## Determination 2009/108

### Code compliance of plywood sheet and plywood weatherboard claddings on a house at 18 Shakespeare Road, Wanganui

**Fig. 1.**

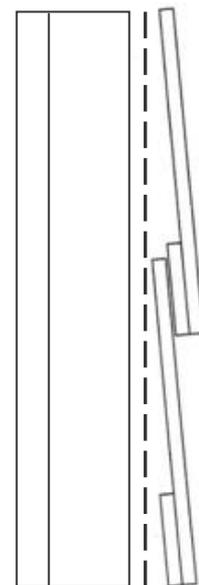
- 2.3 The weatherboards were made by cutting sheets of the plywood into 200mm strips to which 50mm strips (“ribs”) were glued, as shown in Fig. 1. The weatherboards are lapped 40mm or more and fixed through the laps to studs at not more than 500mm centres. Exposed bottom edges of the weatherboards were protected with a proprietary timber preservative coating. Butt joints were glued and covered with copper strips (“soakers”).

- Reliance on sealant at plywood sheet joints
  - Thickness of ply cladding
  - The use of ripped down plywood as weatherboards
  - Grade of plywood used.

- A lack of proven in-service performance
- Use of 3 ply plywood
- Grade of the ply being DD
- Lack of weather grooves.

- The lap joints will not need a weather groove to keep capillary water from the framing and insulation.
- The body of the weatherboards will be acceptably weathertight and free from gravity leakage paths.
- The plywood treated to ... hazard class H3 meets current requirements for plywood used as a non-structural cladding.

- How stable are the weatherboards in relation to cupping and lateral distortion, and how does this depend on fixing and surface treatment?
- Are the butt joints durable and weathertight for the intended life of the cladding?
- Is the adhesive forming the edge thickening appropriate for its application?
- Have all cut edges been protected with preservative?
